## To Our Valued Customers,

This PCN affects our iMX8M Mini uCOM board (product number: EAC00336 and EAC00349).

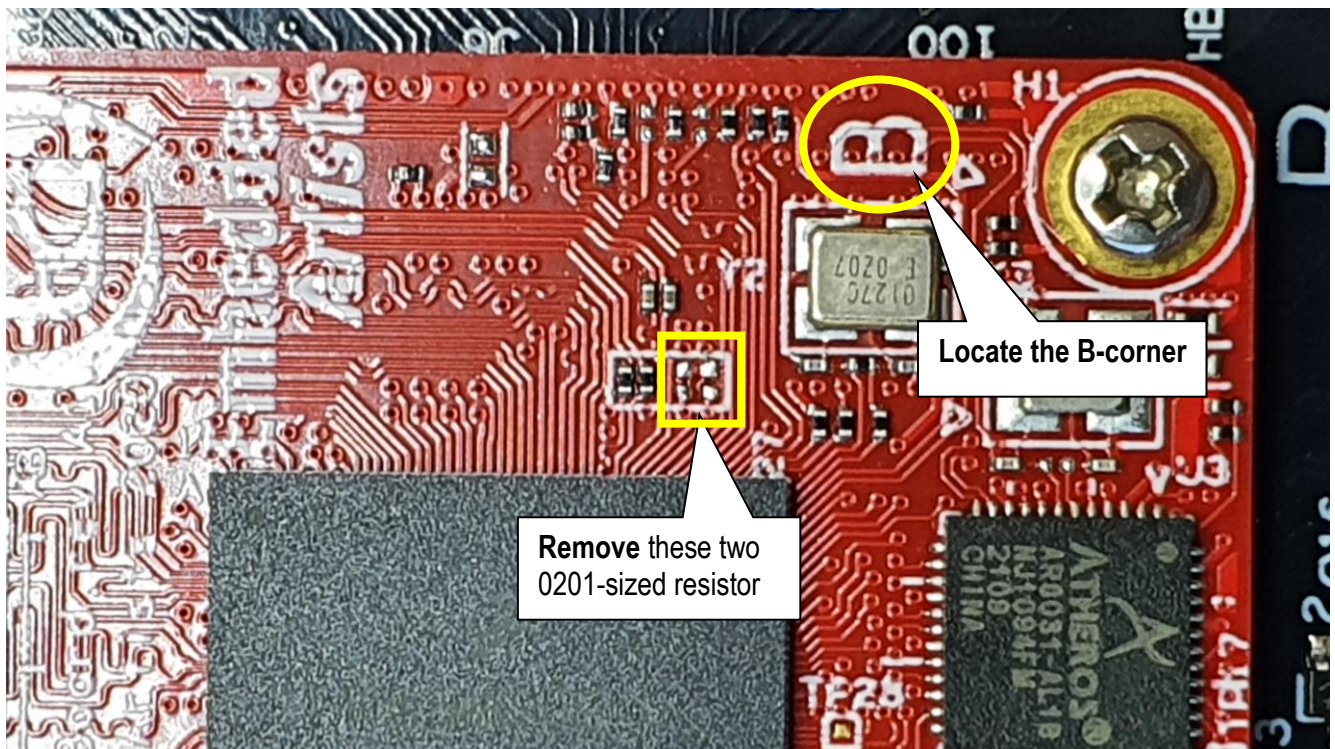
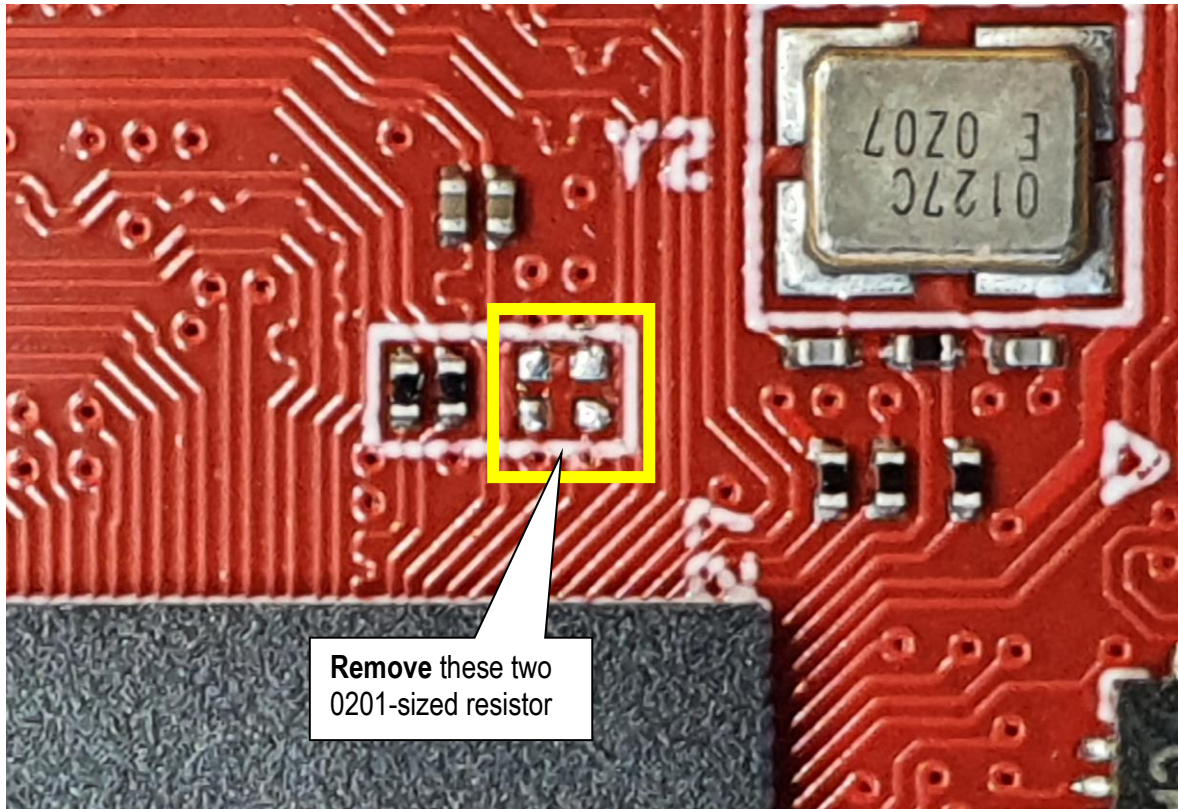
The 100MHz PCIe clock inputs have had incorrect termination on some early board revisions. There are 50 ohm termination resistors to ground close to the clock inputs to the iMX8M Mini processor. The clock inputs on the processor already have internal 50 ohm termination resistors so the external termination resistors will in effect half the clock signal amplitude and hence lower noise margins on the PCIe interface.

The rework is simple and done on the top side of the board, see picture below. First identify the B-corner on the iMX8M Mini uCOM board. Then identify the termination resistors that shall be removed.

The picture below illustrates a more detailed view of the resistors to remove.

No customers have reported any issue, since the margins are very good to start with, but we recommend removing the termination resistors to improve margins.

**Rev PA7, A and A1 are affected.** Rev A2 and higher (rev B1, rev B2, etc) are not affected.
